TOYOTA TECHNICAL SERVICE BULLETIN

REF.: BRAKES
NO.: BR95-003
DATE: AUGUST 18, 1995
MODEL: ALL MODELS

INTRODUCTION OF BRAKE SHIM KITS & BRAKE FITTING KITS

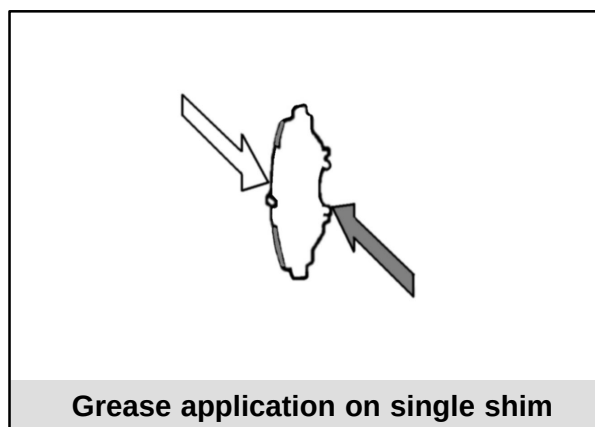
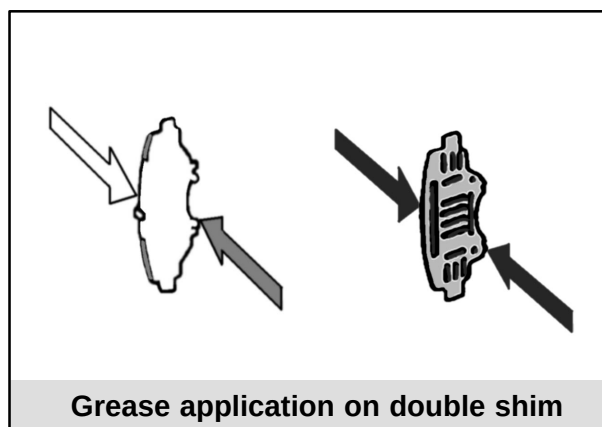
Full brake kits, with complete hardware, have been discontinued. Shim kits and fitting kits for the front and rear brakes are now available separately, along with previously released pad kits.

SUPPLY PARTS CHANGES:

DISCONTINUED PARTS:

Full Kit

NEW PARTS:

Shim Kit

Fitting Kit

UNCHANGED PARTS:

Pad Kit
